SERVICE BULLETIN

ENGINE - HIGH PRESSURE TURBINE ROTOR AND STATOR ASSEMBLY - PROVIDE AN INSPECTION FOR
THE STAGE 2 HPT AIR SEAL - CATEGORY CODE 5 - MOD.ENG-72-0272

V2500-ENG-72-0272

Location of the 2A0487 or 2A1159 Stage 2 HPT Air Seal
Fig.1

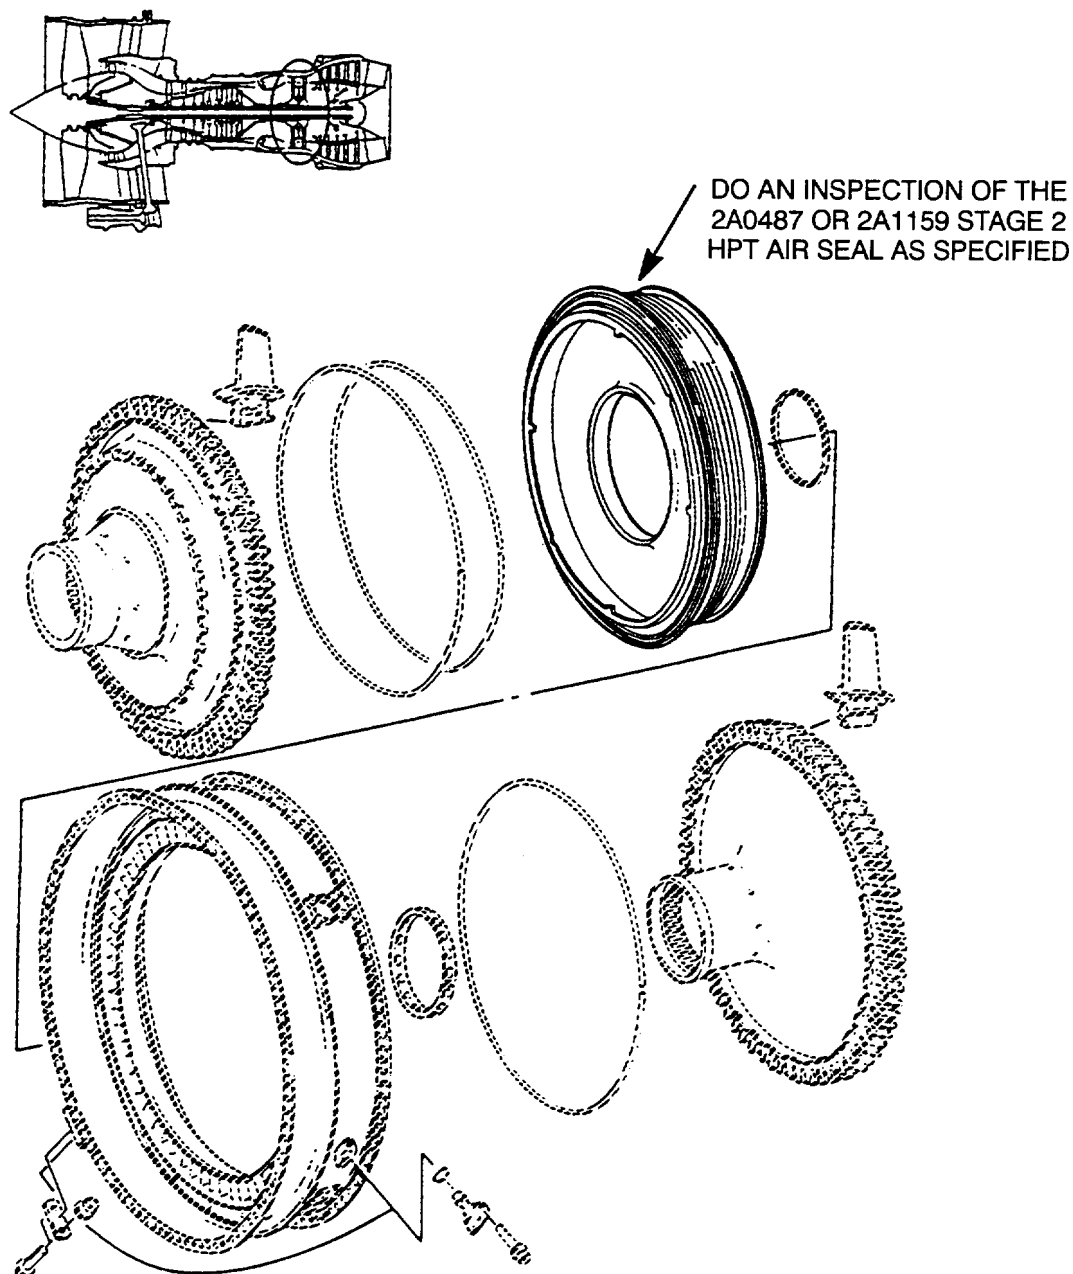
- (2) Do an inspection of the 2A0487, 2A1159 Stage 2 HPT Air Seal to find the dimension at location T. See Figures 1 and 2.
 - (a) Remove seals from service, which are less than 0.147 in. (3,734 mm) at location T.

- (b) You can return seals to service, which are more than or equal to 0.147 in. (3,734 mm) at location T.
 - 1 Mark the Service Bulletin number adjacent to the existing part number. Use the vibration peen method specified in Reference (2), Control No./TASK No. 70-09-00-400-501.
